ORDINARY MEETING OF COUNCIL**23 APRIL, 2013**

The purpose of this report is to outline a planning proposal to amend The Hills Local Environmental Plan 2012 (The Hills LEP 2012) and amendments to The Hills Development Control Plan 2012 Part D Section 6 – Rouse Hill Regional Centre (The Hills DCP 2012).

PART A: Planning Proposal: to amend building height and minimum lot size provisions under The Hills LEP 2012; and

Figure 6
Building Heights – Approved Southern Precinct Plan

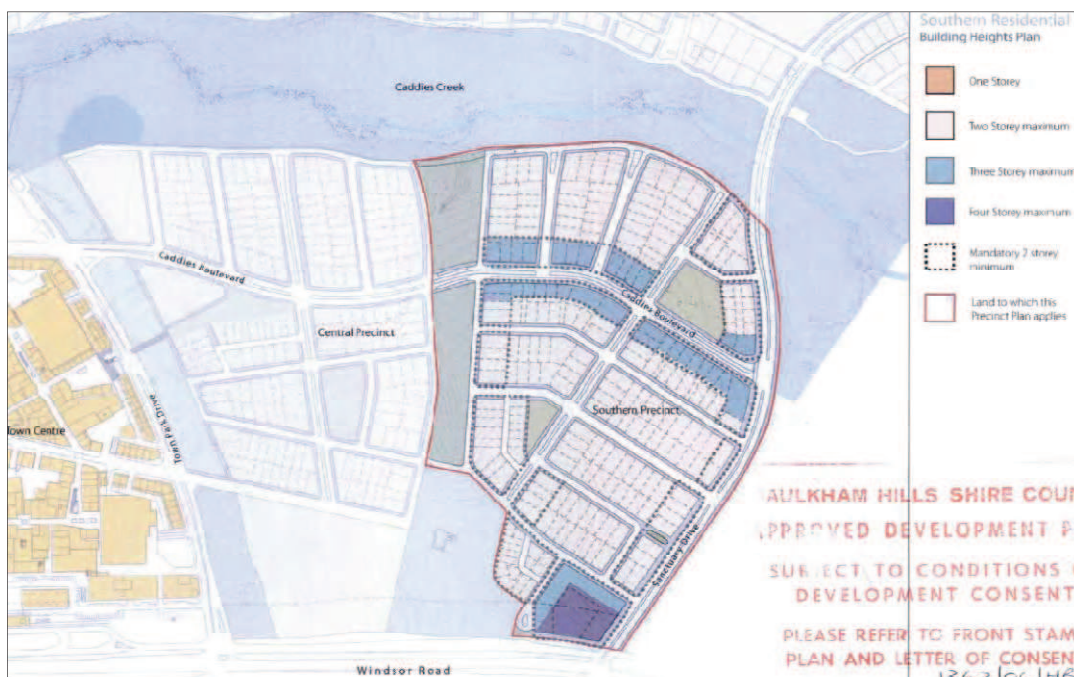
The planning proposal is seeking to increase building height for the Lavender Field site (Southern Precinct) from 15m to 21m to permit six (6) storey residential flat buildings. Whilst the proposed amendment is inconsistent with the approved Master Plan and Precinct Plan for the Southern Precinct (which permit a maximum of three (3) to four (4) storeys) the applicant has argued that additional height is consistent with the DCP and will achieve higher densities in an area with good connectivity to the Town Centre Core and public transport. The image below shows the approved building heights from the precinct plan.

The approved Master Plan includes a vision for a strong southern gateway to the Rouse Hill Centre in the form of a higher density development at the corner of Windsor Road and Sanctuary Drive at the site known as Lavender Field.

Precinct Planning for the Southern Precinct resulted in the following heights being considered appropriate: *"a maximum allowable height of three storeys on the residential streets and four storeys on Sanctuary Drive and the T-Way site."*

Whilst properties along Windsor Road can generally be built with substantial bulk and scale, development fronting the low scale properties to the east should be comparable to the scale of townhouses and detached houses, representative of the R3 Medium Density Residential zone which adjoins. The use of stepped built form as indicated by the Southern Precinct Plan (maximum three (3) storey height to the lower scale housing to the east) is considered important to avoid any adverse impacts such as overshadowing, overlooking and visual impacts. It is considered that this three (3) storey limit should be enforced through any future development application for the site.

Based on Council's DCP floor to ceiling height standard of 2.7m for residential buildings, an increase in height to 21m would facilitate buildings up to seven (7) storeys. However, roof elements or other elements captured by the definition of "building height" such as plant and lift overruns have not been included. As a result an increase the height to 21m would equate to a six (6) storeys of built form as well as any roof, plant and/or lift elements.

- 1.1 It is recommended that the proposed increase in height to 21m be supported on the basis that it will help achieve the objectives of the Master Plan to provide a strong southern gateway to the Centre. It will also achieve State and local strategic planning objectives to increase density around rail stations and locations with good access to shops, services and recreation.
- 1.2 Future development should accommodate a stepped built form to ensure that development facing the adjoining low scale housing to the east is limited to three (3) storeys as provided by the Southern Precinct Plan.

Figure 9
Building Heights – Approved Eastern Precinct Plan

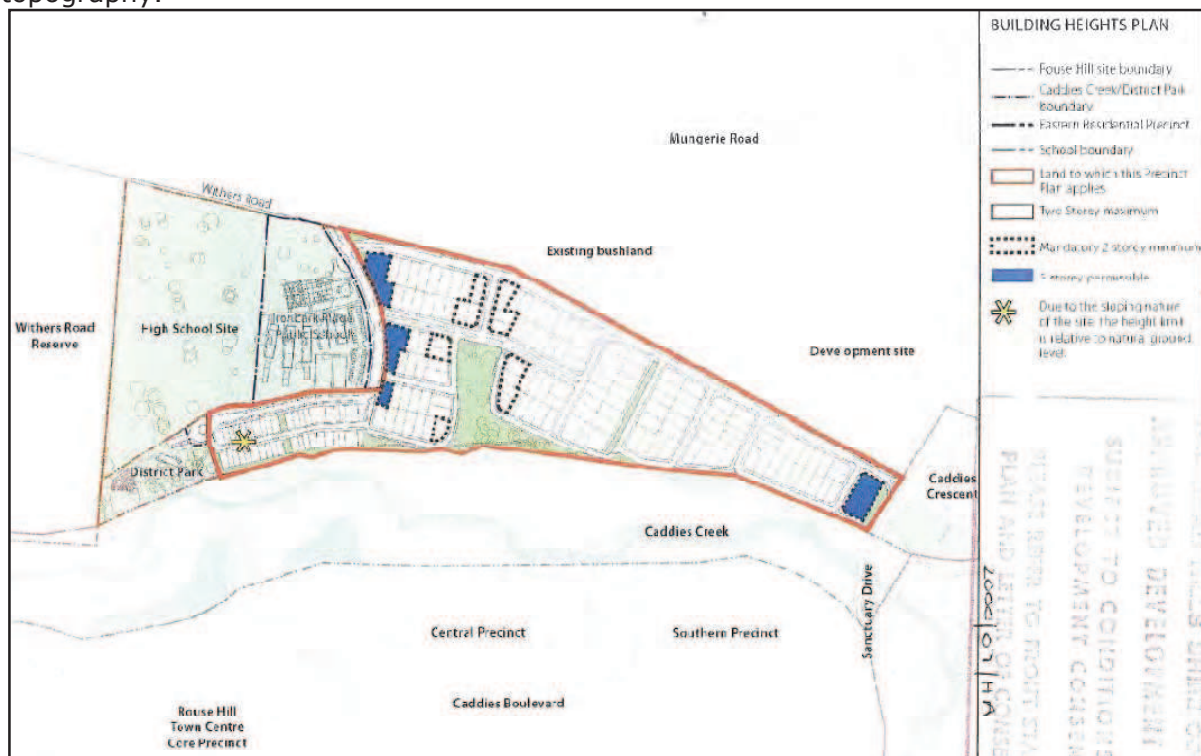
The planning proposal is seeking to increase the building height for a site off Caballo Street in the Eastern Precinct from 10m to 12m. The applicant has argued that additional height is required to facilitate three (3) storey buildings given the site's steep topography.

The proposal to increase the height of the Caballo Street site is inconsistent with the DCP, the approved Master Plan and Eastern Precinct Plan. The precinct plan provides a maximum height of two storeys (maximum 9.5m to the ridge) on the site. However, it does note that the site is a sloping site and provides *"due to the sloping nature of the site, partial third levels such as attic spaces are allowable"*.

The Eastern Precinct Plan provides for three storey development that the "*maximum external wall height is 10m to the underside of eaves and the maximum building height is 12.5m to the ridge*". It is considered appropriate to increase the height to 12.5m for consistency with the precinct plan.

- 2.1 It is recommended that the proposed increase in height to 12.5m be supported on the basis that it is relatively minor and consistent with the height for three (3) storey buildings within the approved Eastern Precinct Plan.

Extract from proposed Central Precinct Plan

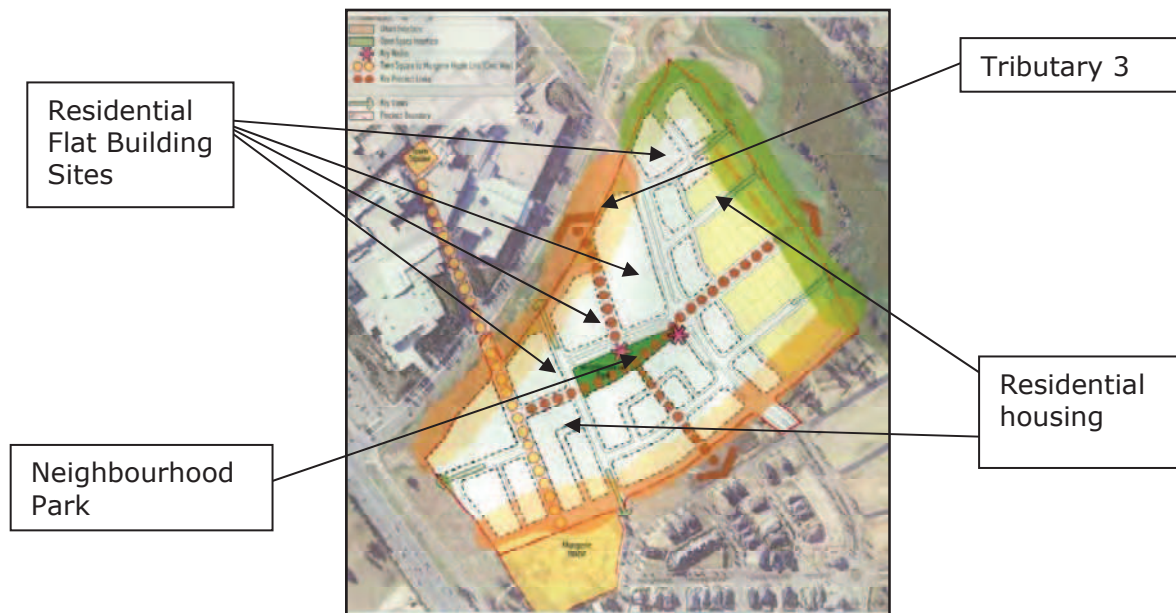
The planning proposal is seeking to increase the height for sites along Tributary 3 from 12m within The Hills LEP 2012 to 21m to facilitate six (6) storey residential flat buildings. The proposal is inconsistent with the approved Master Plan which provides a maximum height of three (3) storeys. The Central Precinct Plan approved by Council on 31 January 2013 does not include building height provisions.

The proposed height will permit residential flat buildings up to six (6) storeys. Whilst this is a significant increase from the height of surrounding residential housing, separation is provided by Tributary 3, the neighbourhood park and the surrounding street network (see below). Additionally, the proposed height provides an adequate transition between the two (2) and three (3) storey buildings to the south in the Central Precinct and the higher order buildings of six (6) to nine (9) storeys to the north in the Town Centre Core.

- 3.1 It is recommended that the proposed amendment to increase the height to 21m be supported on the basis that it will help achieve the objectives of the Master Plan and State and Local Strategic Policy. It will provide higher densities in close proximity to the Town Centre Core and existing and future public transport which will encourage patronage and support principles of transit oriented development.

Figure 11
Example floor plan for a 160m² allotment

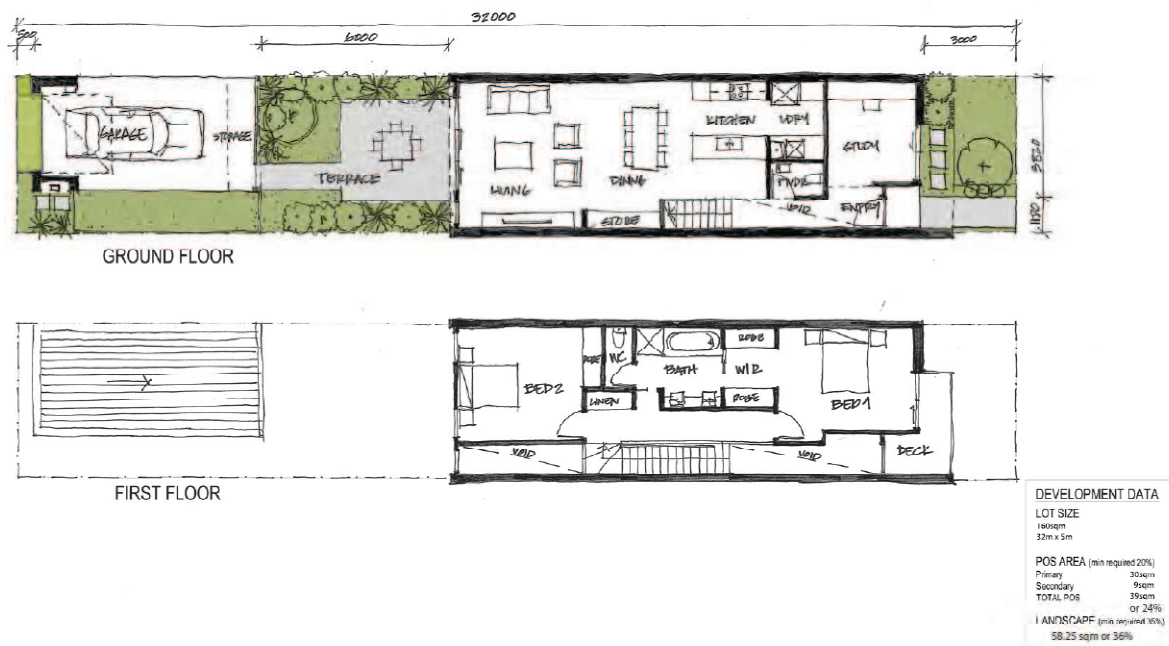
An example floor plan provided by the applicant indicates a 160m² lot on which an attached terrace is situated (below).

The example does not comply with the existing or proposed standards for landscaping/open space. The proposed DCP controls require 40% of the lot area to be allocated for landscaping and open space. This allocation is responsive to the fact that the Rouse Hill Regional Centre offers significant regional open space within the Town Square, Leisure Square and Caddies Creek parkland for the use and enjoyment of residents, to offset a reduced provision within individual developments.

Figure 12
Proposed rear articulation

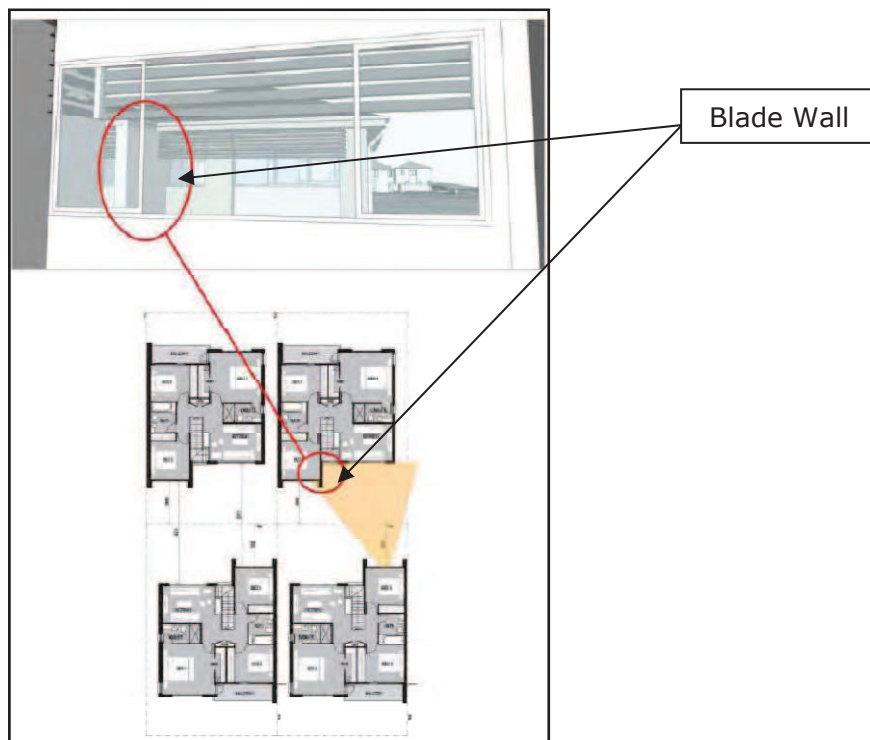
The applicant has argued that the proposed articulation would include a blade wall protruding from the rear of the dwellings, increasing the privacy for adjacent dwellings by interrupting views from bedroom to bedroom for dwellings that share a common rear boundary (see below).

Concern is raised that permitting a 40% or 50% articulation zone will encourage substantial building elements to protrude into the rear setback allowing a portion of the building proper to be located closer to the rear boundary.

Figure 13
Demonstration of articulation zone and proposed building separation

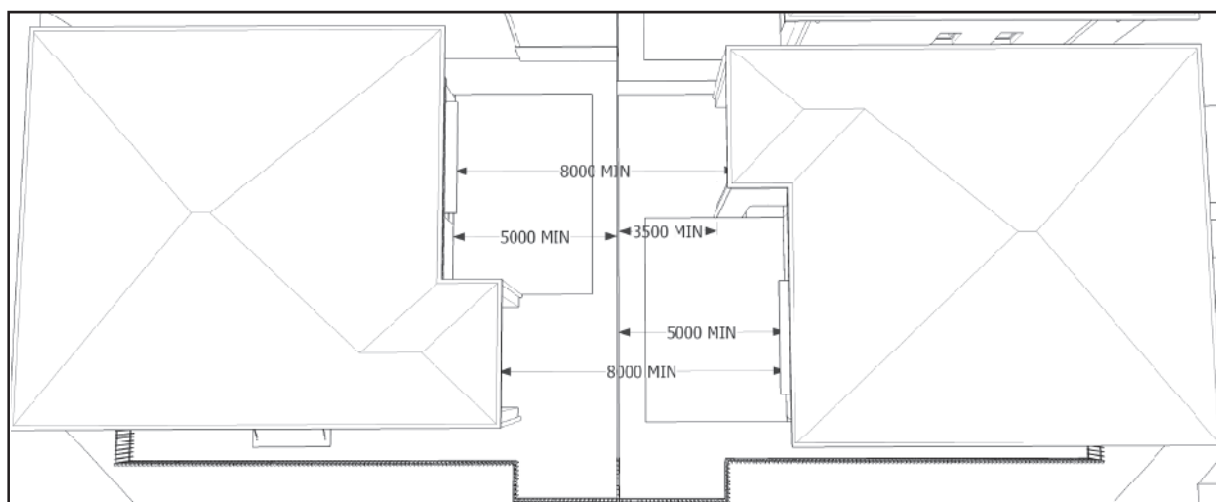
The proposed controls also provide that 8m building separation is required between rear building lines, the intent being to maintain the same separation between buildings as provided by the existing 4m rear setback control. This concept is supported and is shown in the image below.
